BRIEFING SUMMARY SHEET

DEVELOPMENT ASSESSMENT CASE NUMBER: CD-2023-0001

Presentation of a Development Assessment Report for the proposed 500 South Congress Planned Unit Development (PUD), located at 500 and 510 South Congress Avenue, 105 West Riverside Drive, and 407 ½ Haywood Avenue, within the Lady Bird Lake and East Bouldin Creek Watersheds in District Area 9.

IF YOU HAVE ANY FURTHER QUESTIONS CONCERNING THE COMMENTS LISTED BELOW PLEASE CONTACT YOUR CASE MANAGER.

2708 Rialto Blvd., Suite 125 Austin, Texas 78735 Tel: (512) 298-3284 Fax: (512) 298-2592 TBPE # F-14629 GarzaEMC, LLC © Copyright, 2023	
LAND USE	
500 S. CONGRESS PUD PUD 500 S. CONGRESS AUSTIN, TX	
THE RELATED COMPANIES	
DRAWN BY:	DESIGNED BY:
QA / QC:	PROJECT NO.:
SHEET 03 OF 04

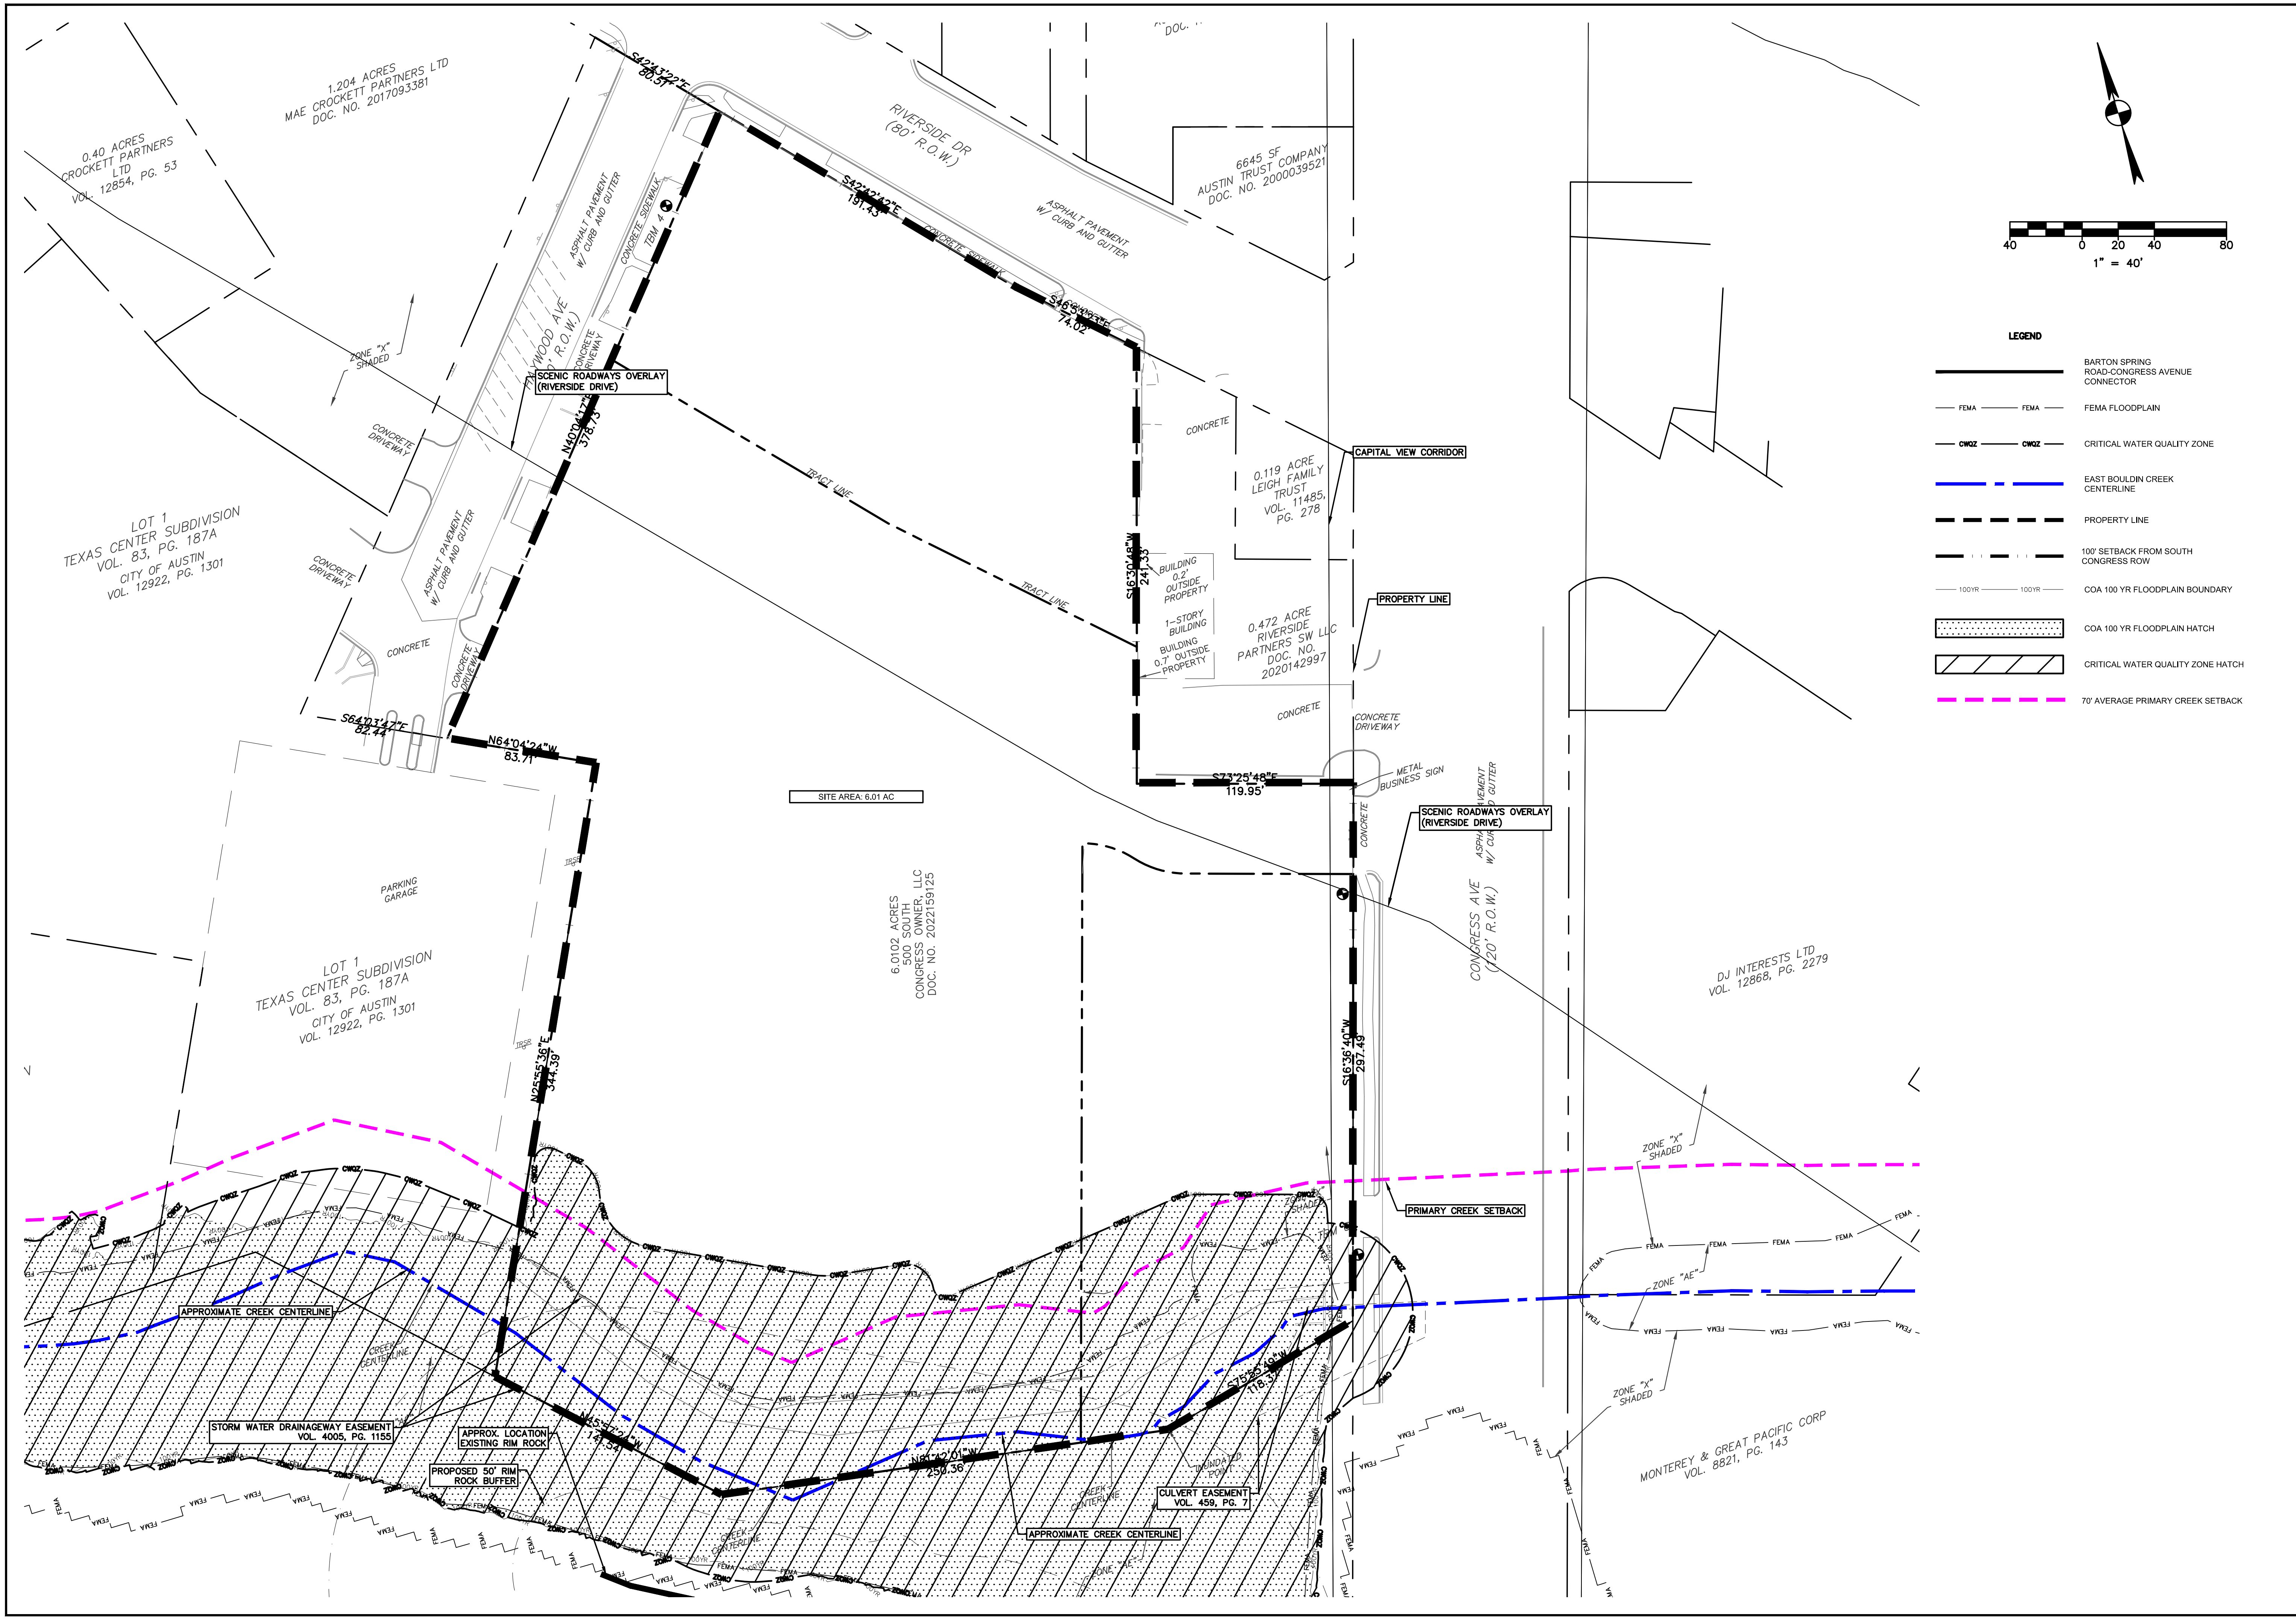
ZN2. What are the minimum and maximum densities (units per acre) proposed of residential, office and commercial uses within the PUD? The current Site Plan Summary Table on the proposed PUD land use plan does not provide this information.

ZN5. On the proposed Permitted Uses table on the draft Land Use Plan:

A) Why is the applicant requesting Outdoor Sports and Recreation and Outdoor Entertainment at this location? Is the applicant planning to develop a stadium use on this 6-acre property?
